PRODUCT SUPPORT BULLETIN N

MACHINE: **LS AUTO-LIFT, S/N 500 to Present**

SUBJECT: Main Frame Bending

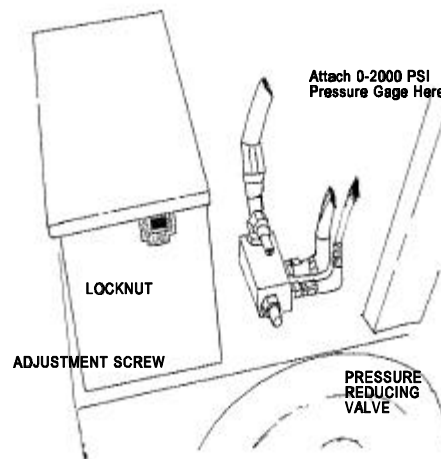
There have been some instances of the Auto-Lift Main Frame bending and welds cracking. The primary cause of frame failures is improper adjustment of the 1606 400 Pressure Reducing Valve for the Clamp Cylinders. This valve is preset at 1500 psi and used in different applications on Nordco Machines so it cannot be preset for a particular machine. When the valve is installed on an Auto Lift it must be reset to 500 psi. See illustration.

If the 1606 400 Pressure Reducing Valve is not reset the excessive load on the frame will result in a bent frame and cracked welds. The high pressure will also result in excessive wear and short life on the rail clamp components.
